**CITY OF MERIDIAN
FINDINGS OF FACT, CONCLUSIONS OF LAW
AND DECISION & ORDER**

In the Matter of the Request for Annexation of 5.25 Acres of Land with an R-15 Zoning District; and Preliminary Plat Consisting of Forty-Three (43) Buildable Lots, Eleven (11) Common Lots and One (1) Other Lot on 4.97 Acres of Land in an R-15 Zoning District for Ascent Townhomes, by Matt Schultz, Schultz Development.

Case No(s). H-2020-0039

STAFF REPORT COMMUNITY DEVELOPMENT DEPARTMENT

D. Qualified Open Space Exhibit (REVISED) & Site Amenity Detail

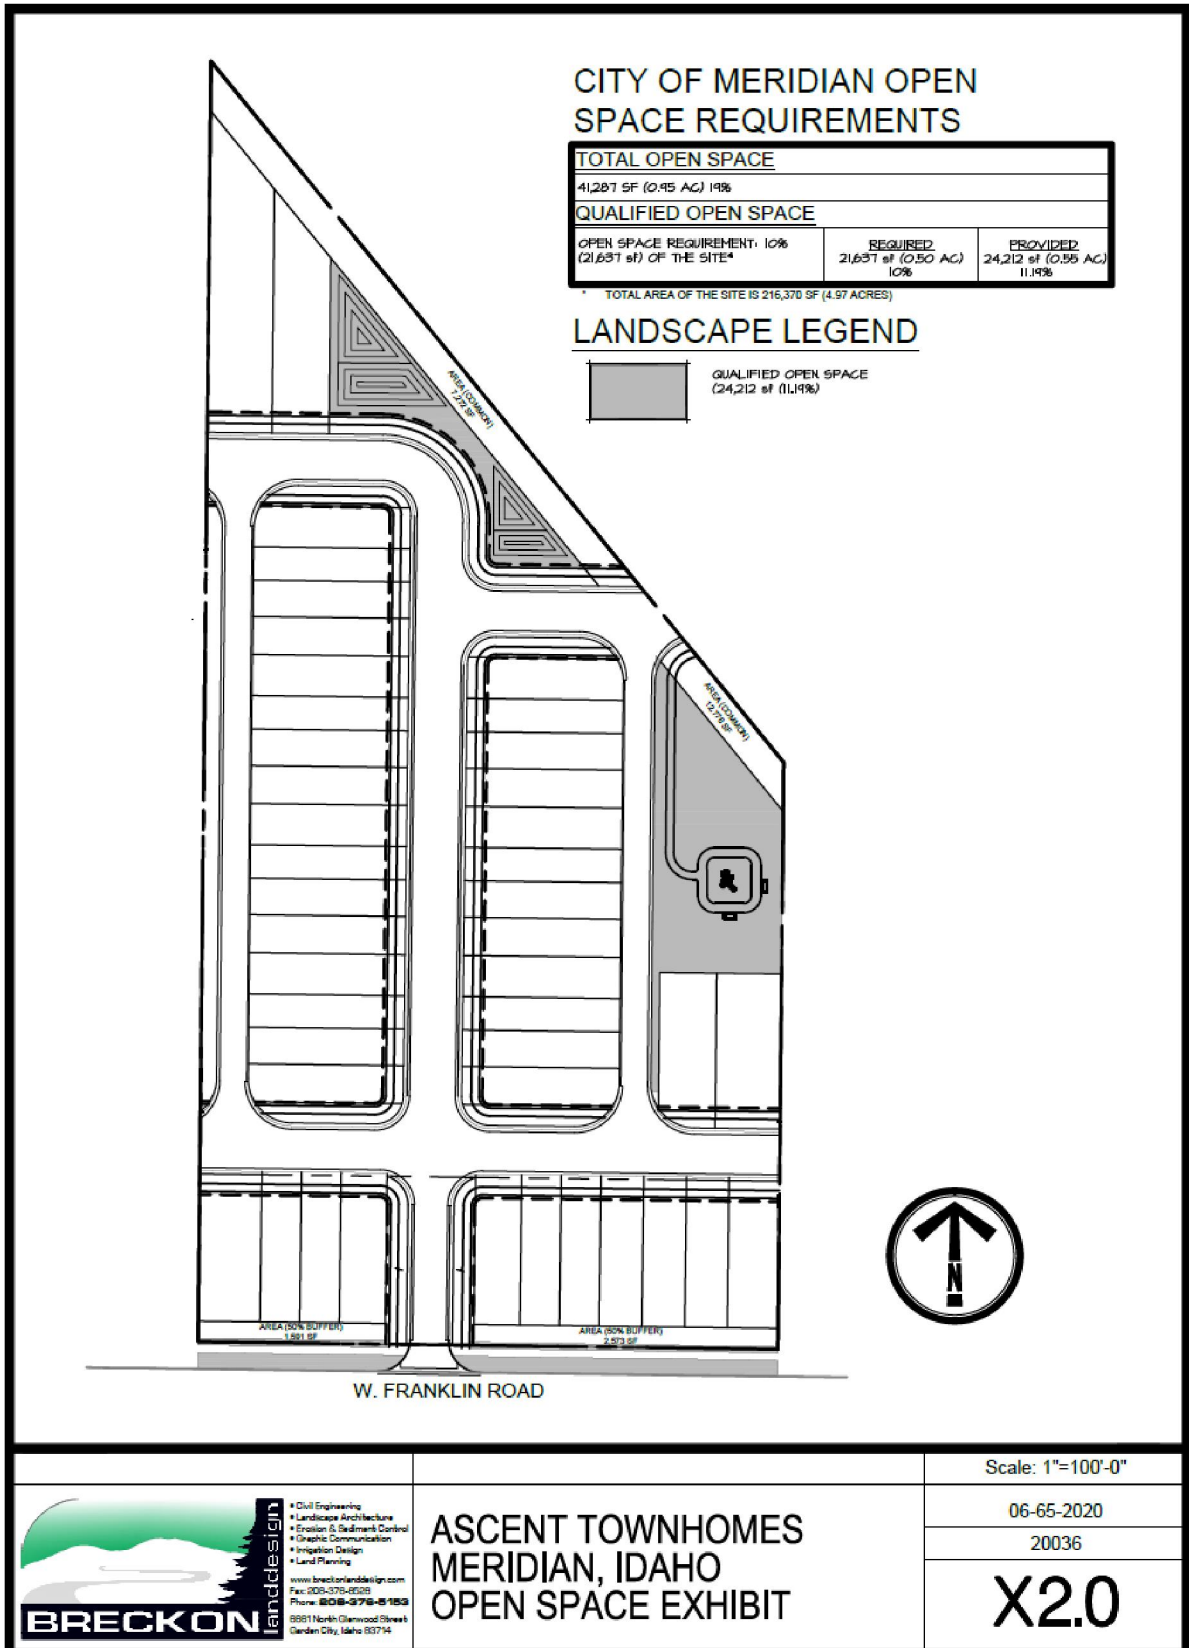
4. The Applicant shall provide children's play equipment as an amenity for this development as proposed per the detail in Section VIII.D.
5. All alleys shall be constructed in accord with the standards listed in UDC 11-6C-3B.5. All alleys shall be signed "No Parking Fire Lane" and have an address sign at each entrance to the alley; each residence that has a back to an alley shall have an address posted on the front of the building as well as on the alley side.

F. Conceptual Building Elevations/Perspectives & Floor Plans – REVISED 5/21/20

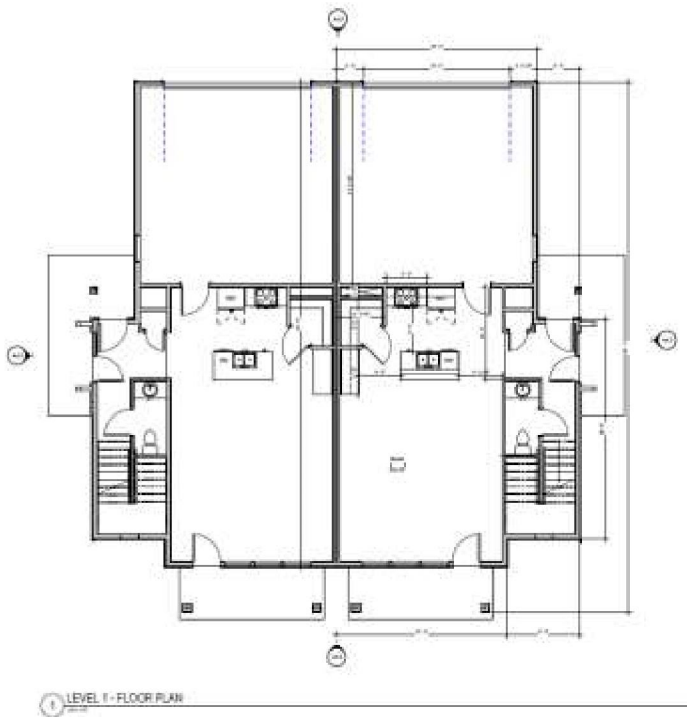
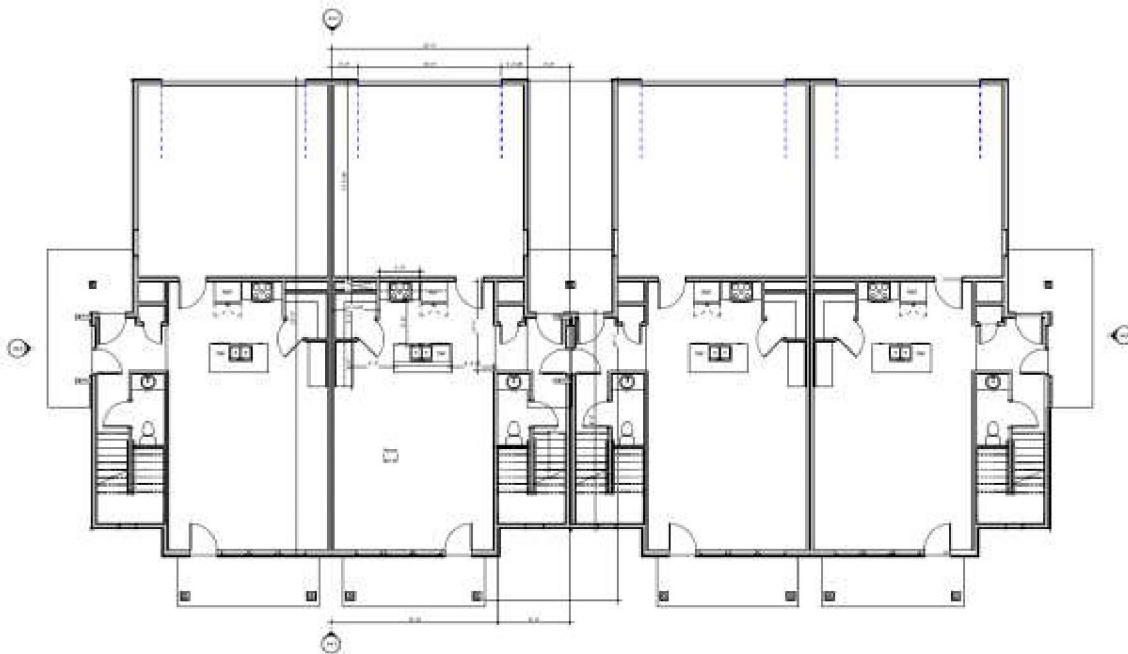
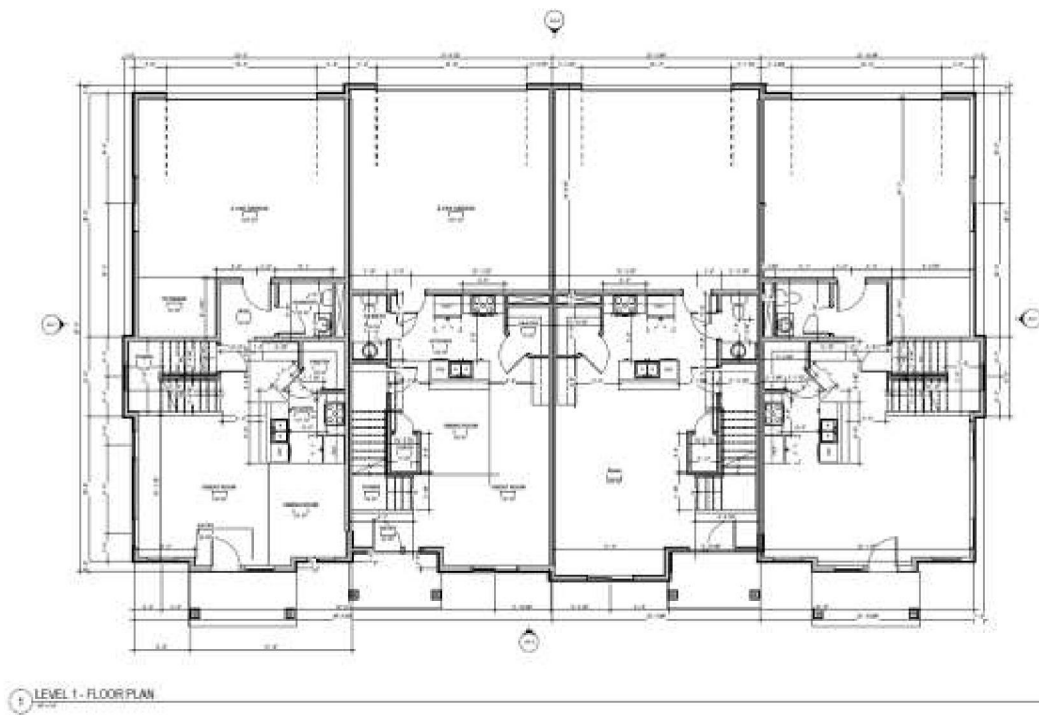
All of the proposed elevations for front-loaded homes depict one garage door instead of separate garage doors for each parking space as required – these elevations should be revised to reflect separate garage doors for each parking space in accord with the Plan.
